City of Phoenix

Staff Report: PHO-2-22--Z-47-17-8

APPLICATION #: PHO-2-22--Z-47-17-8

REQUEST: 1) Modification of Stipulation 1 regarding general conformance with the site plan date stamped July 28, 2017.
2) Review of conceptual elevations by the Planning Hearing Officer per Stipulation 4.

PRELIMINARY
SITE PLAN

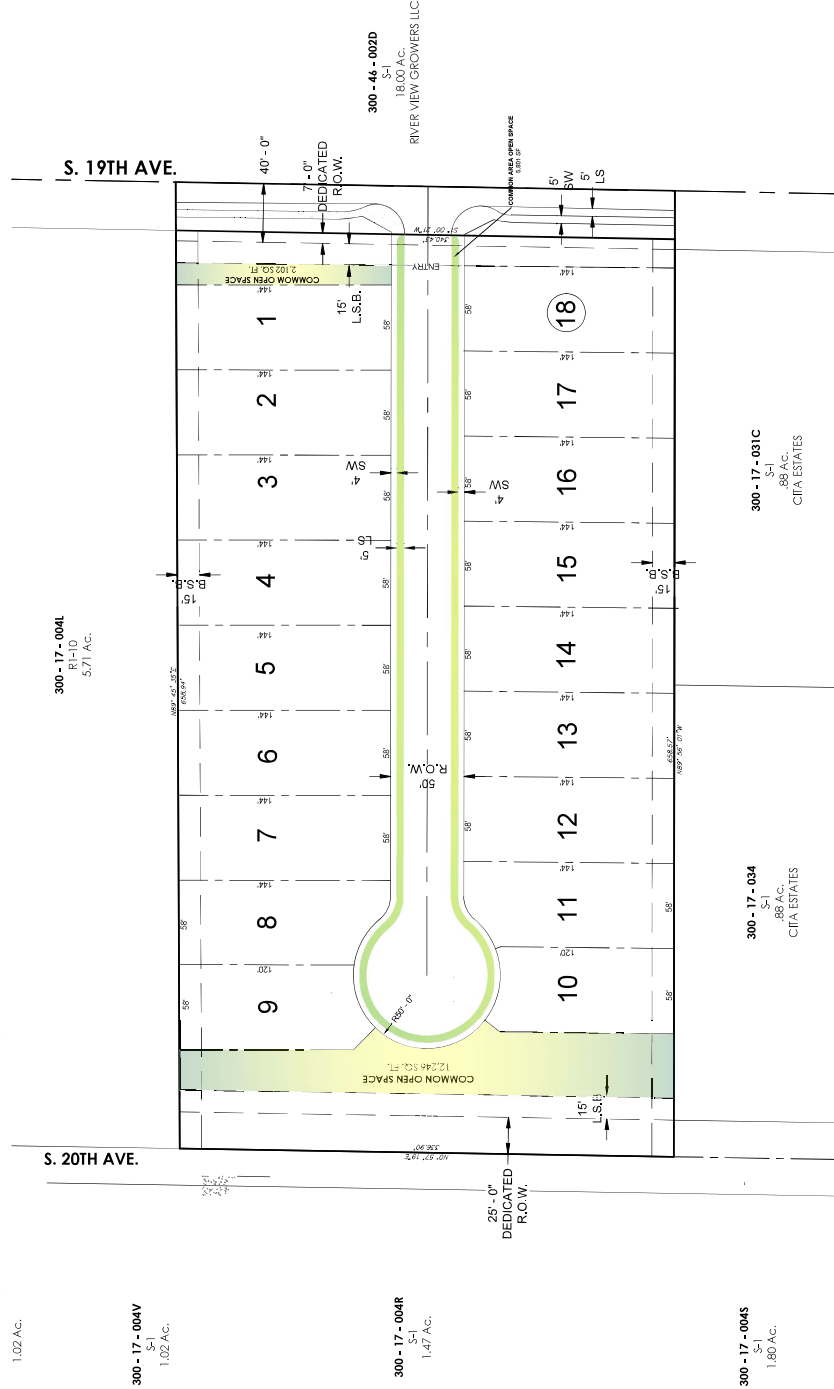
The proposed conceptual site plan depicts an 18-unit single-family subdivision at approximately 3.51 dwelling units per gross acre, with approximately 9% open space. Units are arranged along a street running east/west through the site. The street terminates in a cul-de-sac along the west property line. Most of the open space is along the west property line. The proposal is substantially similar to the stipulated site plan, with the caveat that it is designed with less than half of the original area. The density remains below, and the open space above, Ordinance standards. The proposal is compatible with existing development in the surrounding area.

A new sub-stipulation is recommended requiring staggered front setbacks. This recommendation is consistent with the recommendation of the South Mountain Village Planning Committee. It is also consistent with design recommendations in the Rio Montaña Area Plan (Page 39, Figure 71).

Mr. Stranieri provided an overview of the proposed conceptual site plan and stated that the density depicted consists of approximately two more units than what would be permitted using the density shown on the stipulated site plan. He stated that the change is modest and remains below the maximum permitted density in the R1-10 zoning district. He stated that approximately 9% open space is depicted on the proposed conceptual site plan, which is approximately twice the minimum open space required by the Zoning Ordinance. He stated that a technical appeal may be required regarding the termination of the cul-de-sac on the west portion of the site. Scott Lucas, representative with Terrascope

1.	The development shall be in general conformance with the site plan date stamped JUNE 30, 2022 July 28, 2017 , as modified by the following stipulations and approved by the Planning and Development Department, WITH SPECIFIC REGARD TO THE FOLLOWING:
A.	THE SITE PLAN SHALL DEPICT STAGGERED FRONT SETBACKS FOR COVERED BUILDING ELEMENTS, SUCH THAT ANY TWO ADJACENT LOTS SHALL PROVIDE A MINIMUM VARIATION IN FRONT SETBACK OF 4 FEET.

BELLA ROSA
PHOENIX, AZ
Proposed Elevations

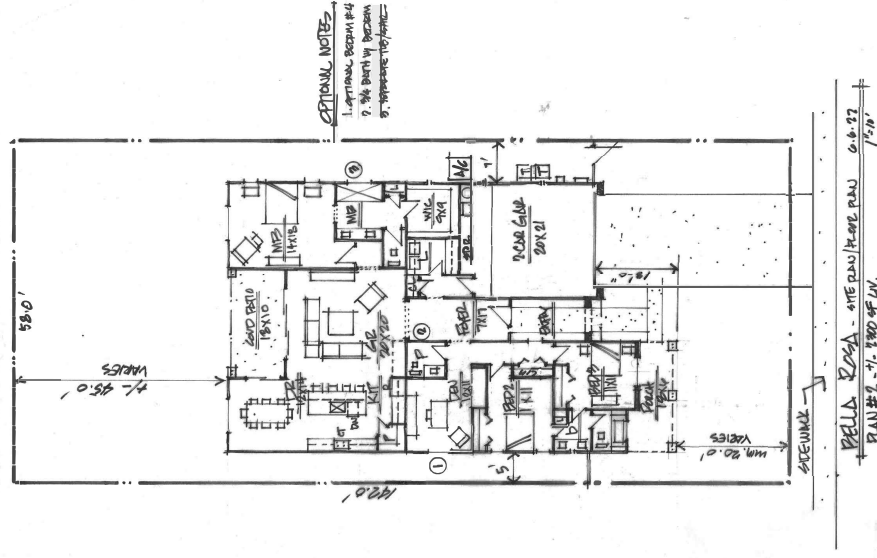
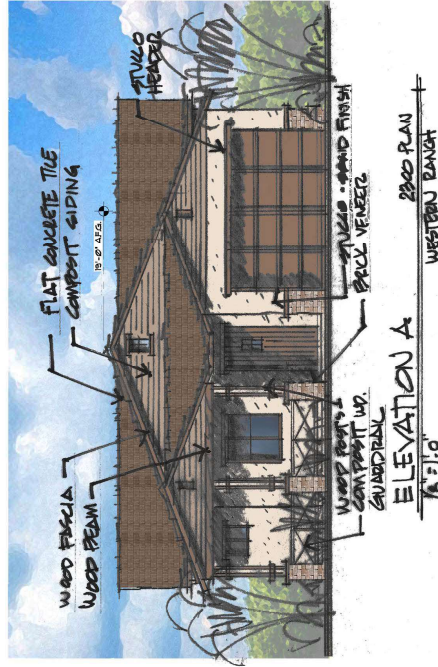
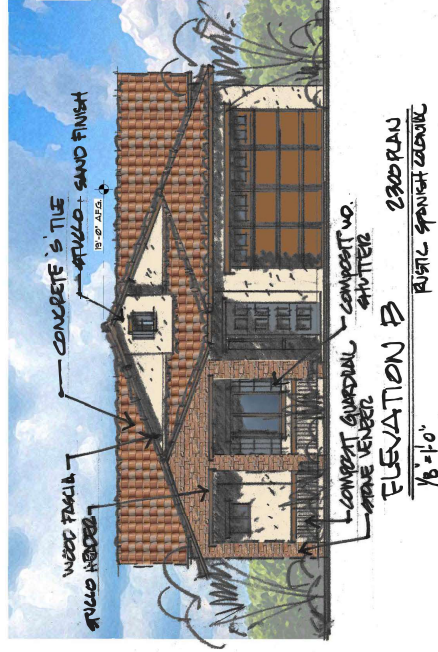
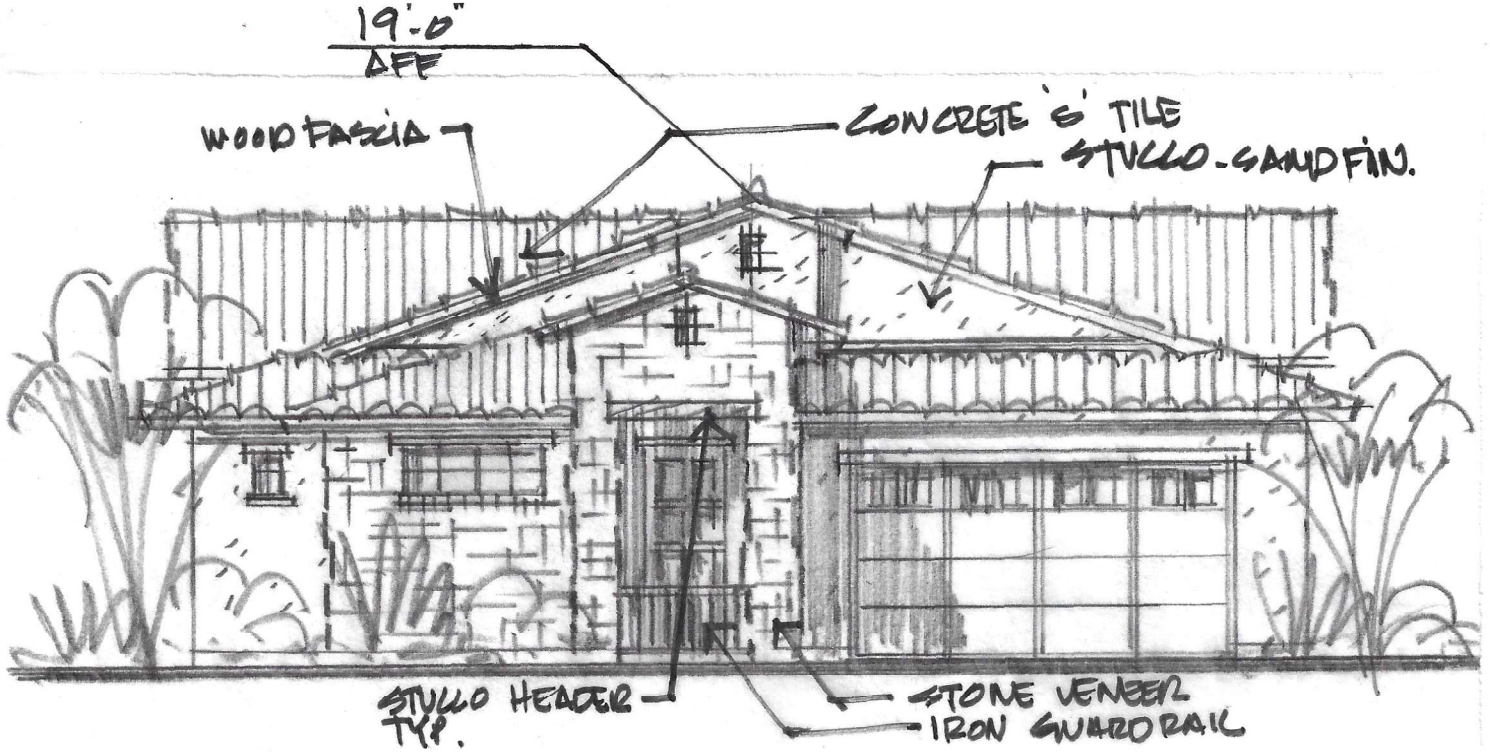
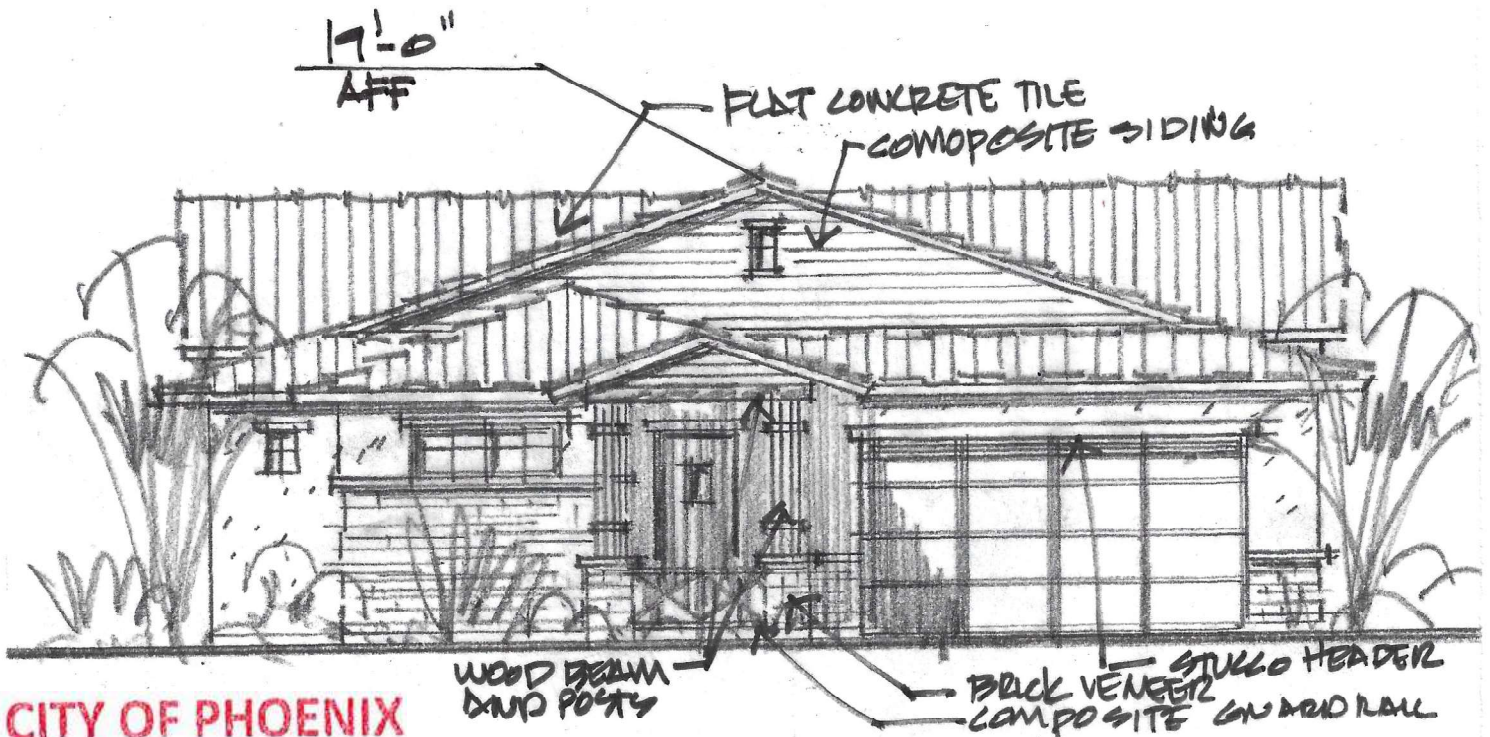
- 3) The applicant submitted conceptual elevations for review and approval per the requirements of Stipulation 4. The stipulation has been complied with and is recommended to be deleted and replaced with a standard language stipulation for general conformance to the elevations provided. Stipulation 4 states that the elevations submitted should be consistent with recommendations in the Rio Montaña Area Plan. The elevations depict a variety of building materials (stone façade, composite siding, wood elements, brick veneer), multiple building colors, variation in roof design, and multiple architectural features (wood posts, gable ornamentation, varied window sizes, decorative garage panels). This diversity is

consistent with the Rio Montaña Area Plan and many of the design choices are compatible with the rural and agricultural character described in the plan.

- 4) An additional stipulation is recommended to require front porches to be provided per the requirements of the Baseline Area Overlay District (651.E.3.b.(4)). This recommendation is consistent with the recommendation of the South Mountain Village Planning Committee. It is also consistent with the Rio Montaña Area Plan (Page 22; Page 23; Page 44, Figures 97 and 100) and the intent of Stipulation 4.
- 5) The Street Transportation Department recommends one additional stipulation addressing required dedications, detached sidewalks, and landscaping along 19th Avenue. This stipulation is recommended for inclusion.

Mr. Valencia presented the elevations while bringing out that some key areas include reduction of garage dominance which could be done by stepping back the garage which all the elevations seem to indicate. Mr. Valencia stated that side loaded garages are closer to the front property line but break up garage dominance because it has windows and acts like a faux front. Mr. Valencia stated that none of the elevations indicate side loaded garages so of the committee wants that they will have to give some specifics such as percentage of elevations to provide that option. Mr. Valencia next mentioned front porches are also characteristic of the Rio Montaña Area Plan and that all the proposed elevations do not indicate porches or their dimensions. All elevations indicate pitched roofs which Mr. Valencia said was another Rio Montaña Area Plan character trait. As well as the variety of materials being proposed.

5.	COVERED PORCHES A MINIMUM OF SIXTY SQUARE FEET IN AREA AT A DEPTH OF AT LEAST SIX FEET SHALL BE PROVIDED IN THE FRONT YARD OF FIFTY PERCENT OF THE HOMES IN A SUBDIVISION. NO PORCH SHALL TERMINATE WITHIN THE PLANE OF A DOOR OR WINDOW.
